DOCKETED	
Docket Number:	23-IEPR-03
Project Title:	Electricity and Gas Demand Forecast
TN #:	249949
Document Title:	Solar Energy Industries Association (SEIA) Comments - 2023 Preliminary Gas Price Projections
Description:	N/A
Filer:	System
Organization:	Solar Energy Industries Association (SEIA)
Submitter Role:	Public
Submission Date:	5/2/2023 2:50:09 PM
Docketed Date:	5/2/2023

2023 Preliminary Gas Price Projections

Comments on the April 18, 2023, *Natural Gas Preliminary Price Projections Webinar* for the 2023 *Integrated Energy Policy Report*

Figure 1: *PG&E Backbone Value less PG&E Annual Firm Backbone Rate*

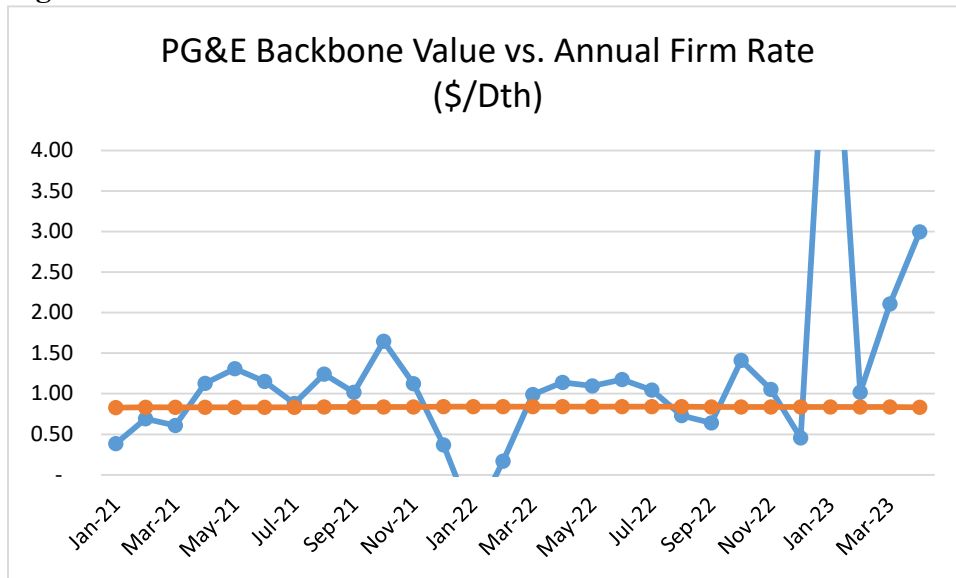
The problems with the use of this “market rate” for backbone transportation on the PG&E system are (1) historically the basis difference between border and citygate prices on the PG&E system has been close to the full cost of backbone transportation on the PG&E system and (2) the lack of any escalation over time in this market rate, even though the underlying backbone rates will increase. For example, **Figure 1** below shows that the difference between PG&E Citygate prices and California border prices in 2021-2023 (the PG&E Backbone Value) has fluctuated above and below the average PG&E Annual Firm backbone rate, with the average PG&E Backbone Value being at least as high as the Annual Firm backbone rate.³

We recommend two alternatives for the CEC to consider: either (1) use Citygate prices for all forecasts, or (2) use California border prices for all forecasts. The current modeling approach for PG&E uses a mix: PG&E Citygate prices for the EG D/T forecast and California border prices for the EG BB forecast. This is confusing and does not reflect our understanding that most EG customers purchase their gas supplies at the PG&E Citygate. If the CEC uses PG&E Citygate prices for both EG D/T and EG BB burner tip costs, it should revise the NAMGas modeling of PG&E Citygate prices to include the use of the full PG&E backbone rate, with 4% annual backbone rate escalation. This would reflect the fact that the difference between border and citygate prices on the PG&E system historically has reflected the full cost of backbone transportation, as illustrated in Figure 1. If, on the other hand, the CEC uses border prices (e.g., 67% Malin, 33% Topock), then the full backbone rate (with 4% annual escalation) should be added to the weighted average border price to yield the PG&E Citygate price.

³ The border and citygate prices used in Figure 1 are monthly bidweek values, and are sourced from PG&E’s monthly avoided cost posting. The large upward spike in the PG&E Backbone Value at the end of 2022 and in early 2023 was the result of constraints on the pipeline and storage infrastructure that deliver gas to northern California.

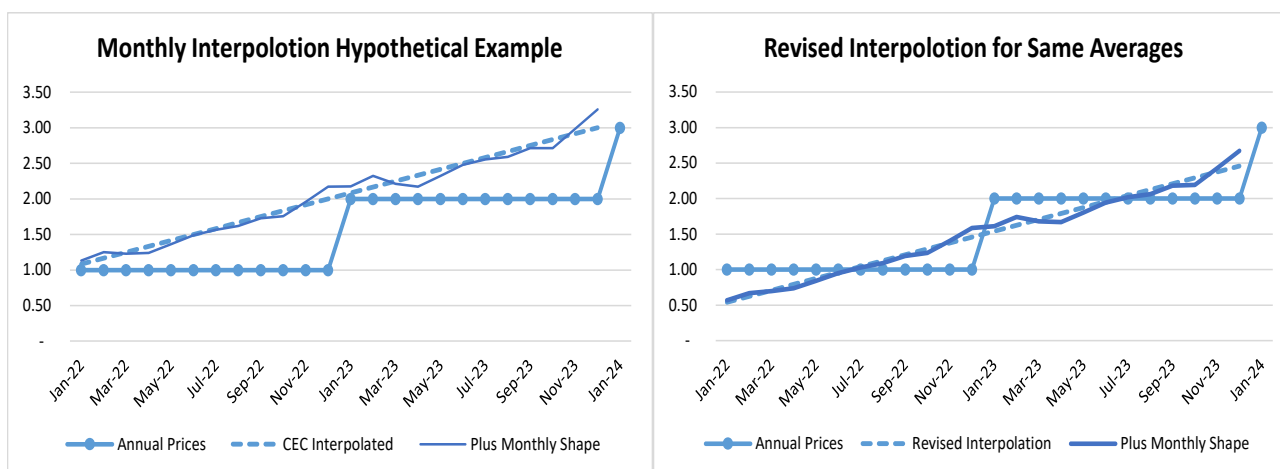
Another minor issue is the CEC’s monthly interpolation of NAMGas annual prices. We assume that the CEC has run NAMGas to produce annual average, rather than monthly average prices.⁵ The CEC then calculates monthly prices that include an increasing amount, during each

month of the year, of the change in the annual NAMGas price forecast from that year to the next year. Thus, (1/12) of the annual price change is added to the price in January, (2/12) is added in February, and so on, until the full (12/12) price change is added in December. While this allows monthly prices in the year to ramp up to the level of prices in the next year, it changes the annual average price forecast. These comments propose a way to eliminate any changes to the annual average gas price. By changing the interpolation addend, from having the same sign in each month of the year, to addends with opposite signs in each half of the year, the CEC can avoid changes to the annual average prices:

- Current Addend = annual price change x [month #] / 12
- Proposed Addend = annual price change x [month # - 6.5] / 12

The following two figures provide a purely hypothetical example (2022 = \$1.00/Dth, 2023 = \$2.00/Dth, and 2024 = \$3.00/Dth), simply to illustrate the issue; the first figure shows the CEC's current approach, and the second figure shows a similar approach that does not alter the annual averages.

The figures above also include the Henry Hub (January 2009 to February 2023) average monthly price shapes. The CEC also should make a final minor correction to the monthly price shapes used in the draft forecast, so that the monthly shapes average to 1.0 annually. This small correction is that a single set of price shape factors should be calculated based on average monthly prices over the multi-year period (2009-2023), rather than averaging the price shape factors for each individual year of that period. Also, it appears that the 2017 shapes used a 2016 average price in the denominator – but this issue would be corrected with the above recommendation to compute average monthly prices over the multi-year period prior to calculating the monthly price shape.
